Re: Site Plans for 3 Burke Lane, Wellesley

Below is a list of revisions to the Guerriere & Halnon, Inc. Site Plans dated August 29, 2019. Revisions 1-18 address comments from meetings with the Zoning Board of Appeals on June 4, 2019 and July 18, 2019, the Fire Department on June 10, 2019, and the Department of Public Works on July 2, 2019. Revisions 19-32 address comments from the most recent meeting with the Zoning Board of Appeals on August 6, 2019, the Department of Public Works Peer Review Letter dated May 9, 2019, and the VHB Transportation Peer Review Letter dated July 31, 2019.

Site Plans
For
3 BURKE LANE
In
Wellesley, Massachusetts

Date: April 16, 2019
Revised: August 29, 2019

Typical Retaining Wall Cross Section
Not to Scale

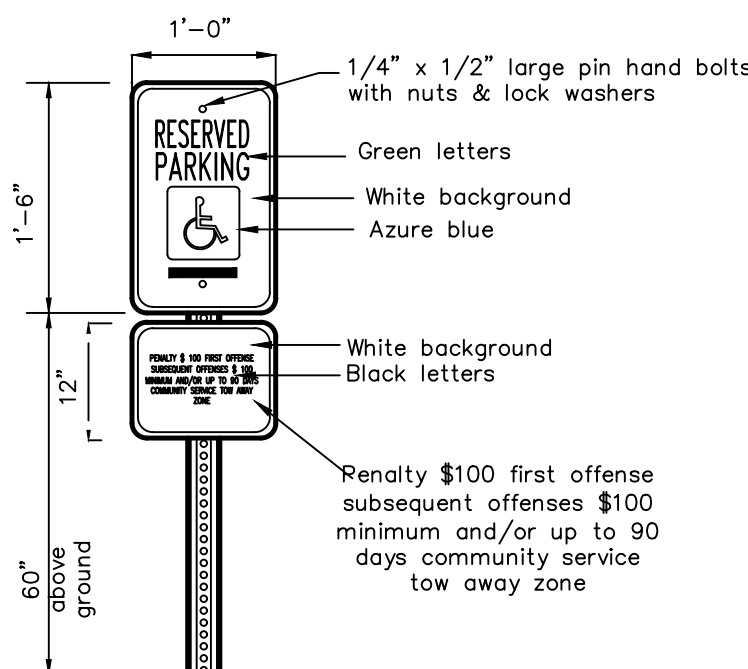
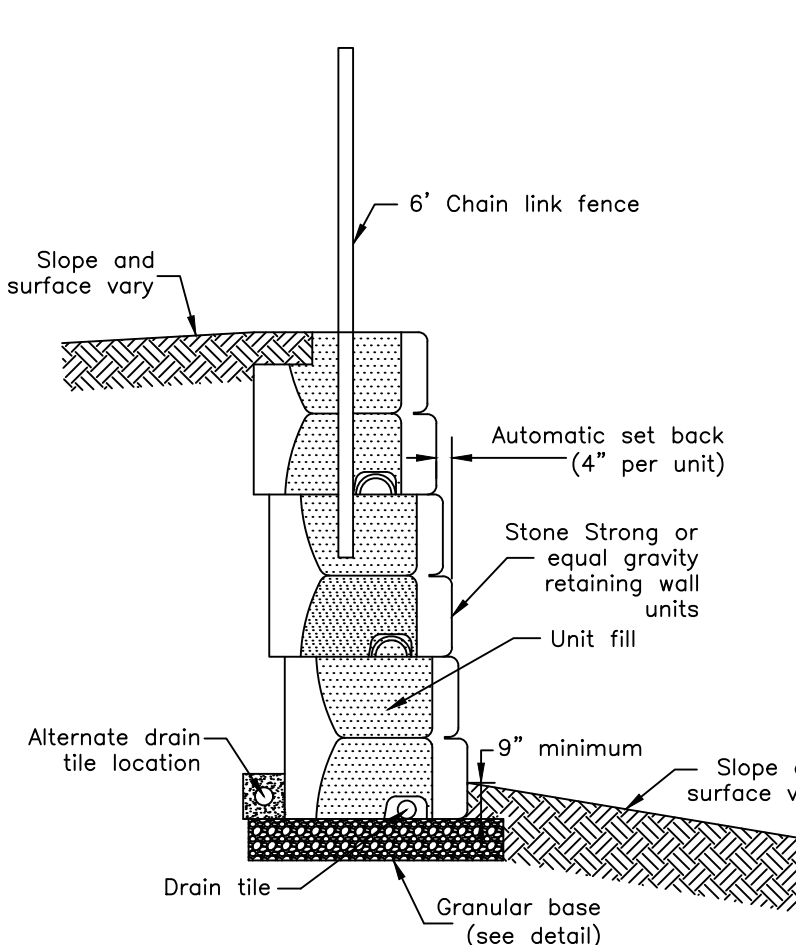
23. The western retaining wall was revised to remove an encroachment onto the 7 Burke Lane property as well as provide 10' of separation to the proposed building on Sheet 3. The retaining wall drainage pipe layout was revised on Sheet 3 per Redi-rock Shop Drawings. A note was added to the typical detail on Sheet 4 for fencing along the wall.

SHEET
5 OF 8

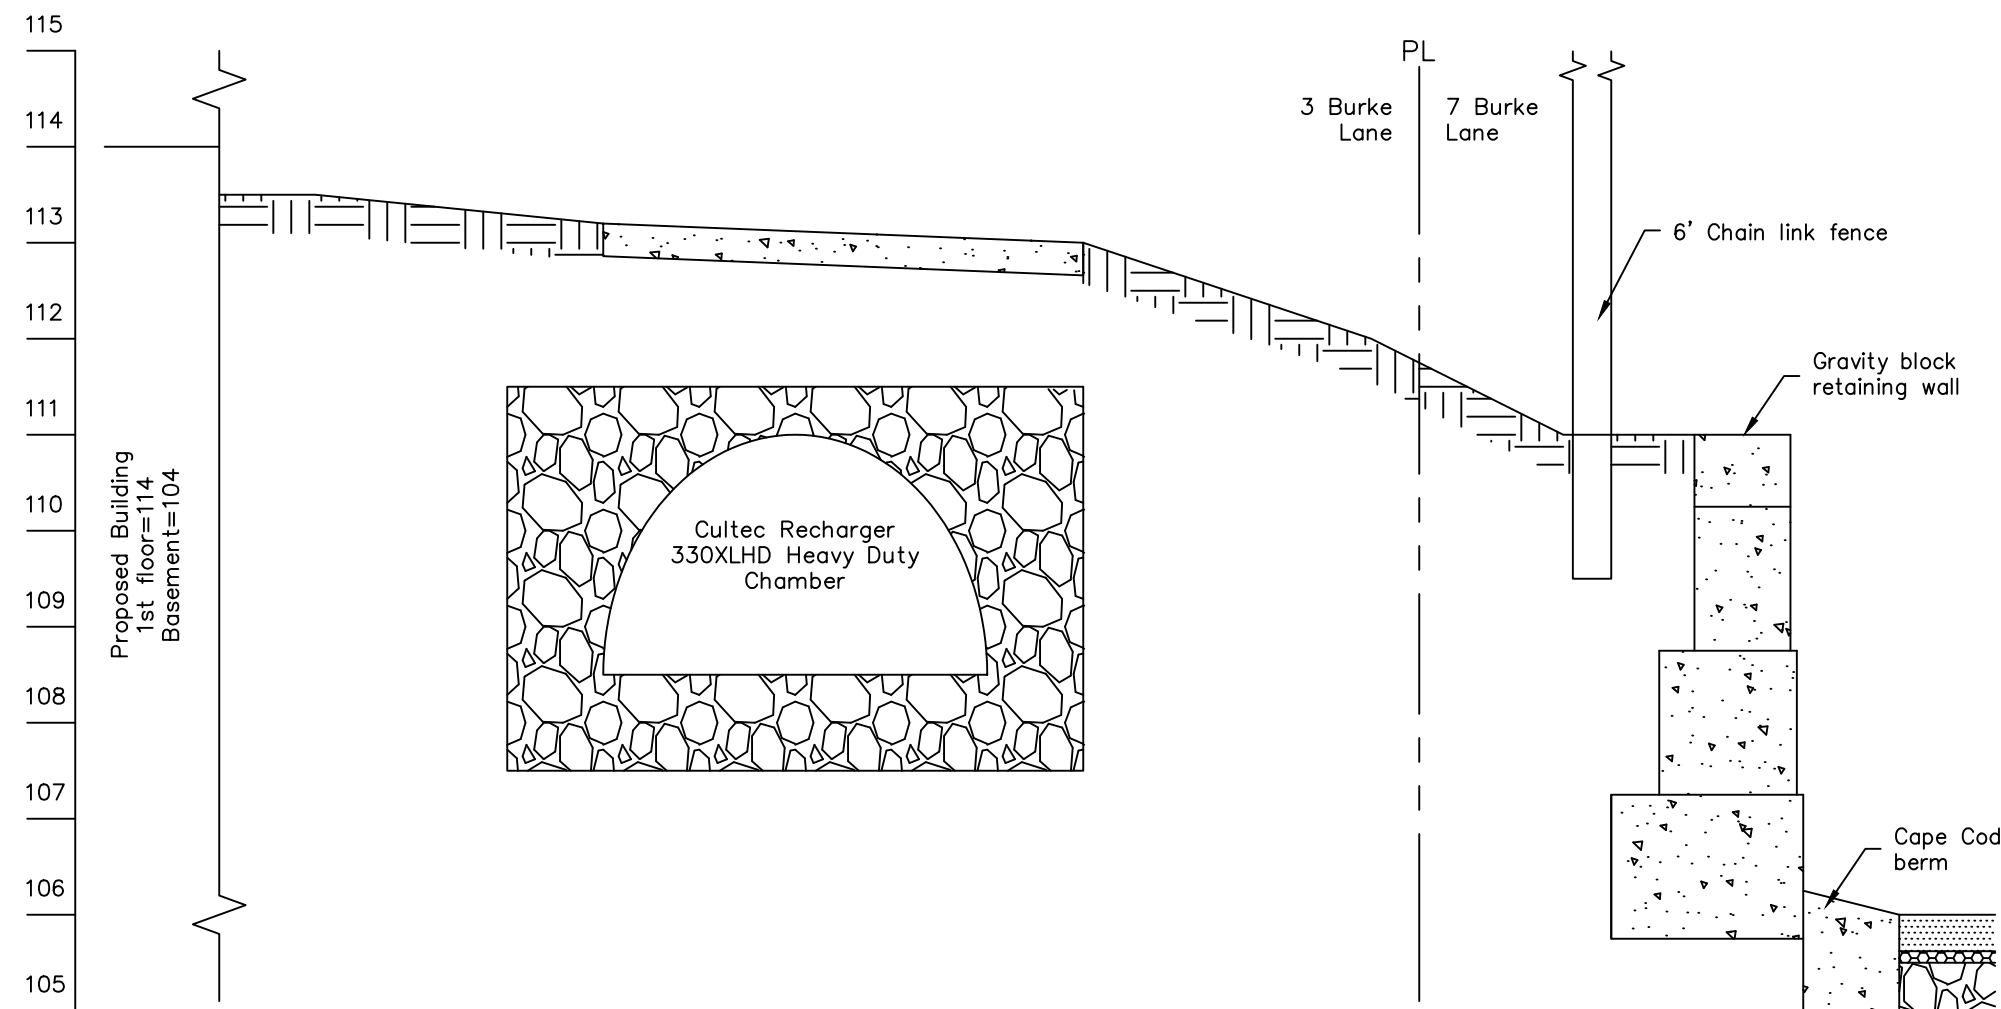
3. Stairs to the 7 Burke Lane parking lot were added to Sheet 3 for emergency personnel access.
4. Cut & fill analysis summary was added to Sheet 4.
5. Infiltration chamber design elevations were raised. Callouts on Sheet 3 as well as details on Sheet 5 have been revised accordingly.

Cross Section A-A
V scale: 1"=2'
H scale: 1"=2'

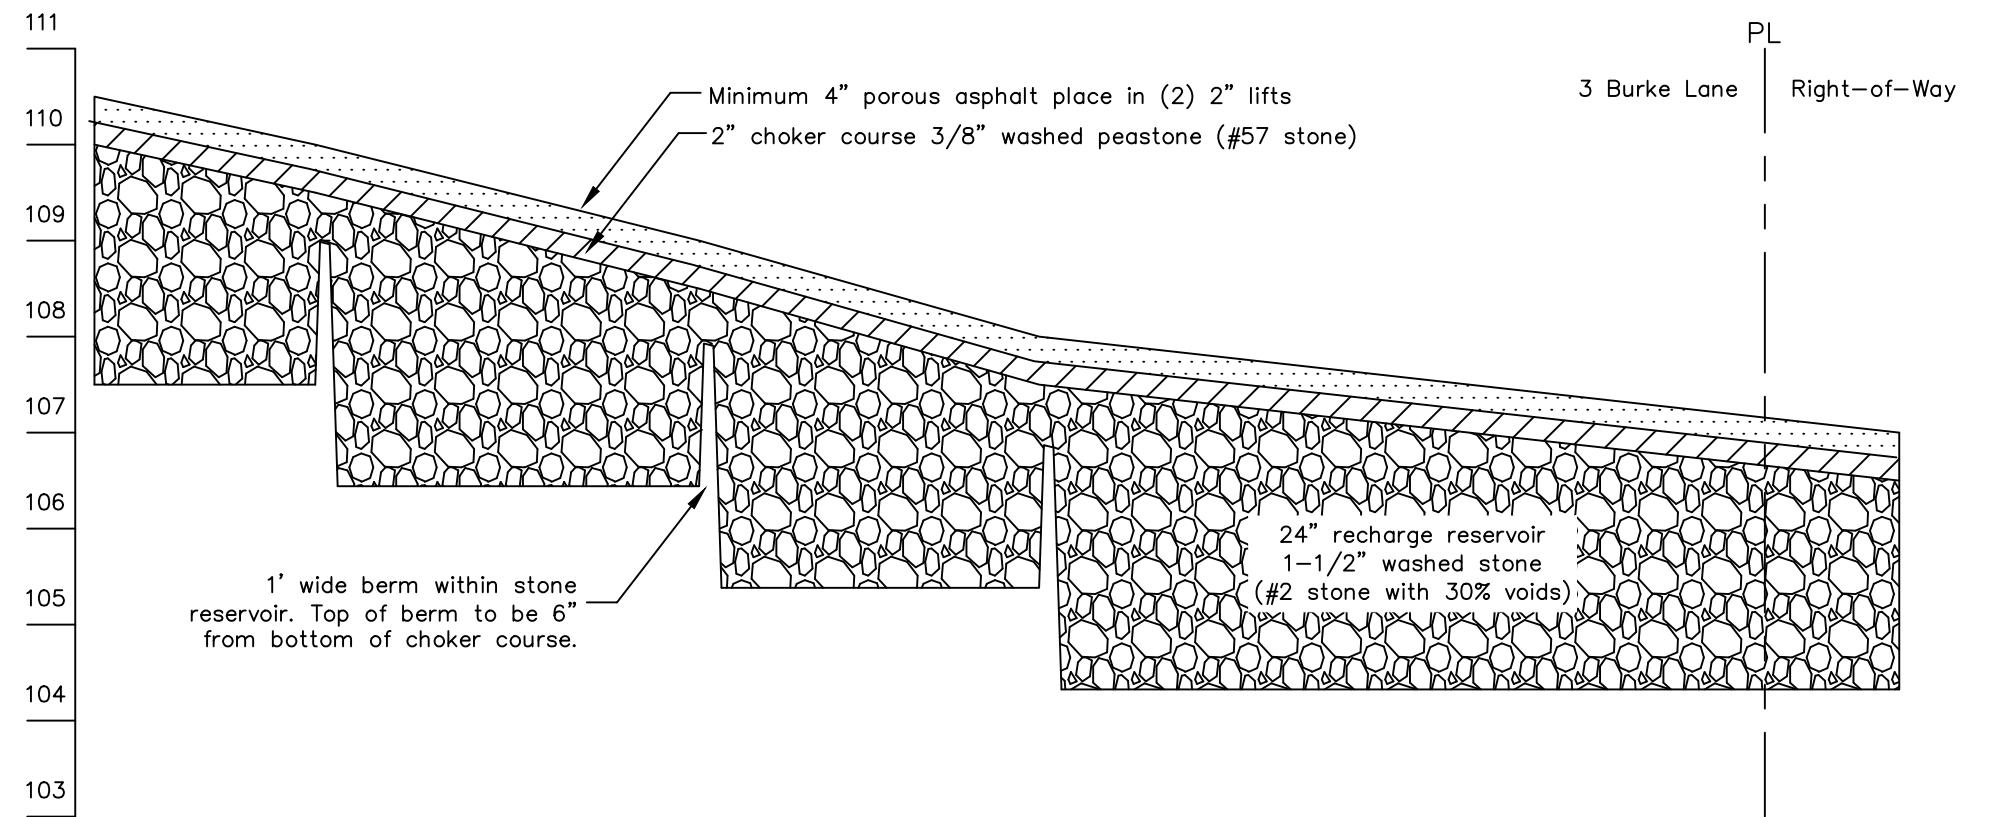
8. A note for retaining wall drainage was added to Sheet 3.
9. Three (3) cross sections were added to Sheet 6 with callouts shown on Sheet 3.
10. Two (2) proposed handicap stalls were revised to be van accessible on Sheet 3.

Perspective View from #15 Burke Lane
Not to Scale

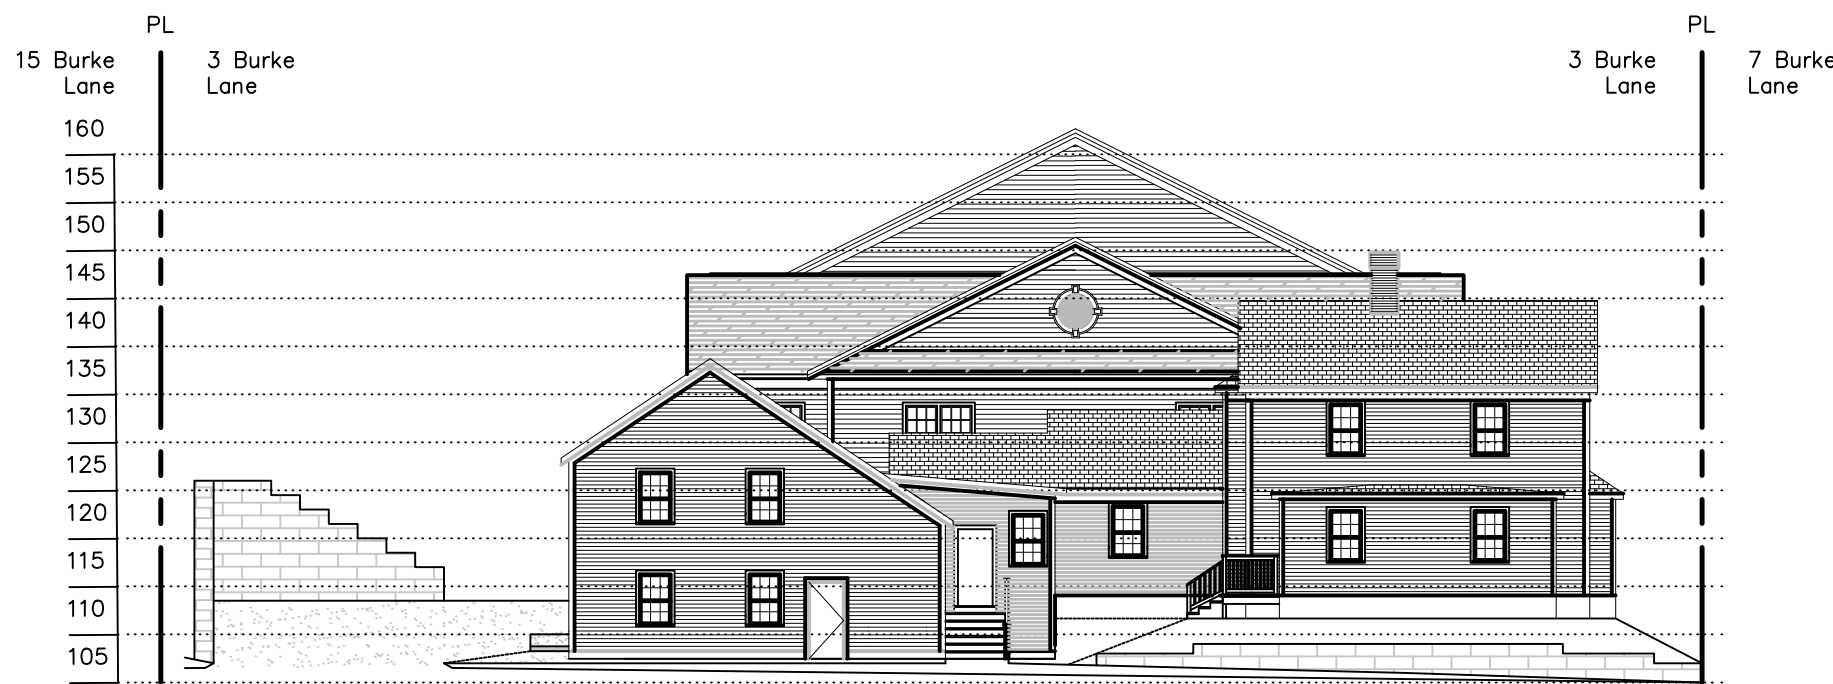
31. Soil logs were moved from Sheet 4 to Sheet 5.
32. Three (3) perspective views were added to Sheet 6.
